Cedar Lake Parkway/I-394 Light Rail Alignment Assessment Technical Memorandum

May 2016

Southwest LRT Project Technical Memorandum

SOUTHWEST LIGHT RAIL
CEDAR LAKE ALIGNMENT OPTION

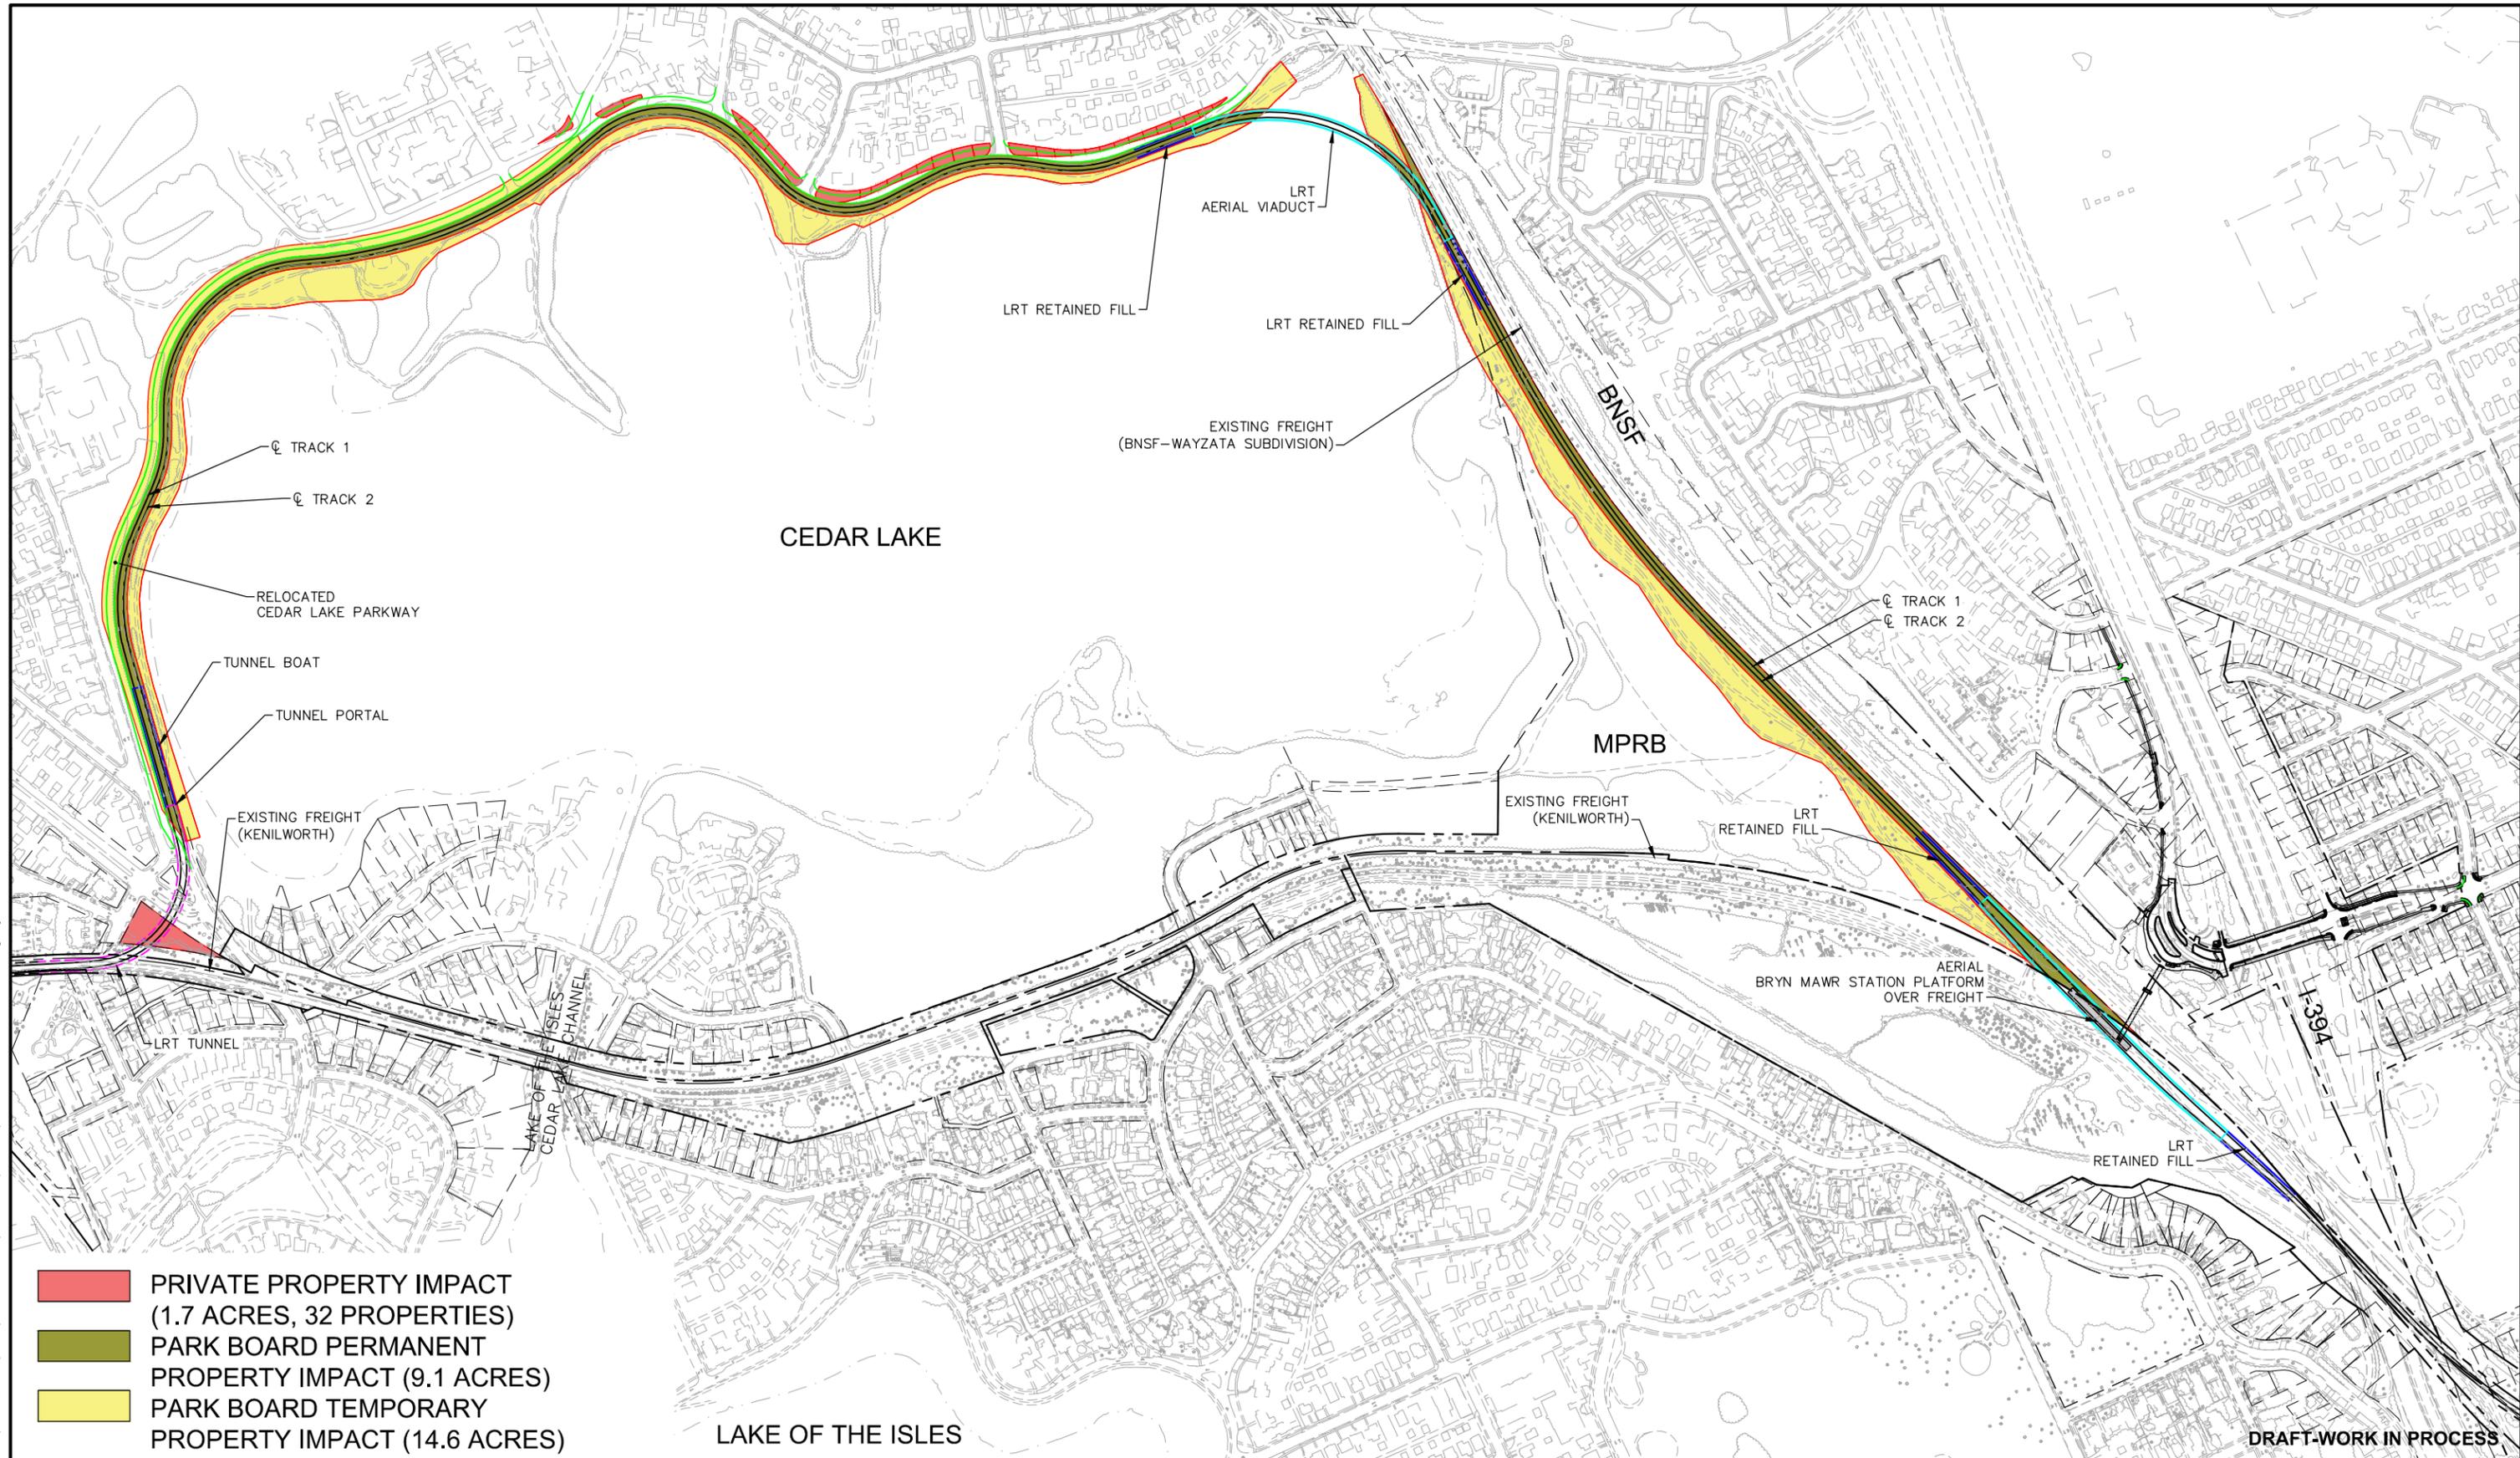
So, I have another route suggestion. I understand that Lake St is forecasted to be the busiest station. So run the train to there and then turn it North to run along Cedar Lake Pkwy until it meets the rail corridor just S of 394. This path catches Benilde HS and Jones-harrison traffic. This path eliminates the Kenwood corridor, the project biggest headache with its cost and environmental concerns.

Based on the proposed light rail alignment along Cedar Lake Parkway, FTA and the Council and have determined that this alternative route would substantially increase some adverse environmental impacts, compared to the Project. Those impacts would include adverse effects to and the use of portions of Cedar Lake Park and Cedar Lake Parkway, both of which are federally-protected Section 106 historic and Section 4(f) park properties. In particular, the proposed light rail alignment would use approximately 7.6 acres of Cedar Lake Park, which is owned and managed as a significant park and recreation area by the Minneapolis Park and Recreation Board, compared to the Project's use of approximately 0.4-acre use of the Kenilworth Lagoon/Grand Rounds Historic District (both Section 106 protected properties). In addition, the proposed Cedar Lake Parkway alignment would result in the displacement of multiple residences on the west side of Cedar Lake Parkway due to the relocation of Cedar Lake Park to the west to accommodate the light rail alignment (associated with the acquisition of approximately 1.7 acres of residential property, which would fully displace a condominium complex and result in partial acquisitions of 31 other properties), compared to the Project, which would result in no displacement of residences.

Further, because the proposed light rail alignment would increase the length of the light rail alignment and because it would involve several tighter radius curves than under the Project, light rail travel time in this segment would increase under the proposed alignment change, compared to the Project. The increased light rail travel time would tend to reduce Project ridership.

Because the proposed light rail alignment alternative would increase the noted adverse environmental impacts, increase light rail travel times, and tend to reduce Project ridership, compared to the Project, the Council and FTA dismissed the proposed alternative light rail alignment along Cedar Lake Parkway/ I-394 from further study.
